©Kawasaki Motors Corp 1974 Printed in USA

PROBLEMS:

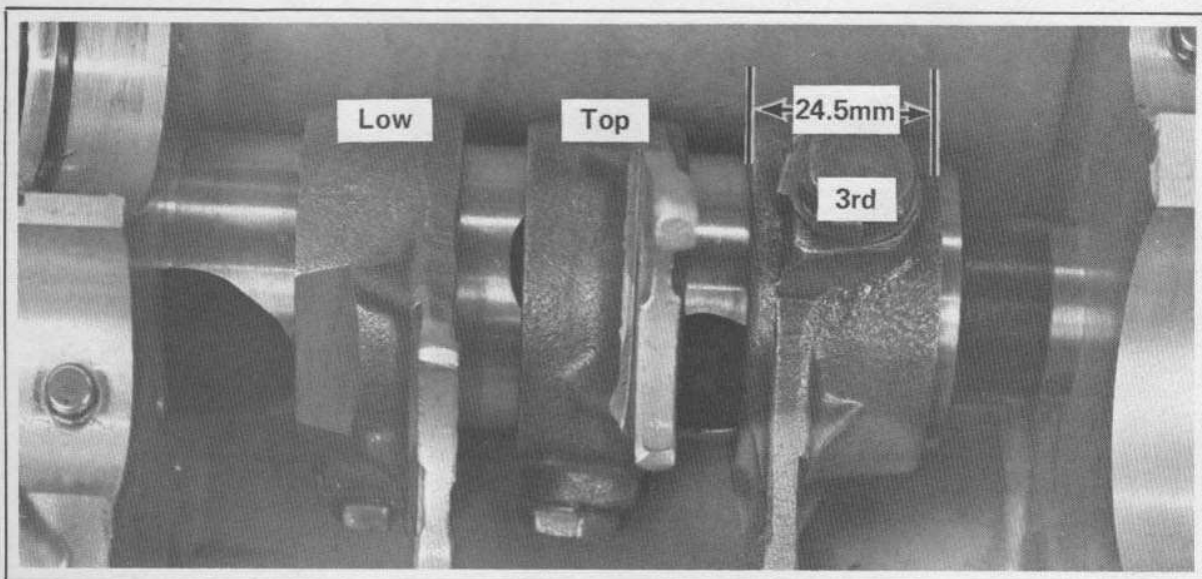
H1/H2 transmission problems have often included poor third gear engagement. This may be caused by two possible problems including the play of the fixed gears on the shafts and the lack of positive action in the third gear shift fork.

The second problem has been countermeasured by widening the base of the shift fork to keep the fork more rigid on the shift drum. This wider fork is supported on both sides of the groove on the shift drum.

The new fork is easily recognized by its wide base.

DESCRIPTION	OLD PARTS		NEW PARTS		INTER- CHANGE	EFFECTIVE I.D.
	P/N	REMARKS	P/N	REMARKS	OLD↔NEW	
3rd gear shift fork H1	13140-013	21.0mm wide	13140-064	24.5mm wide		KAE-87023
3rd gear shift fork H2	13140-048	21.0mm wide	13140-065	24.5mm wide		H2E-31941
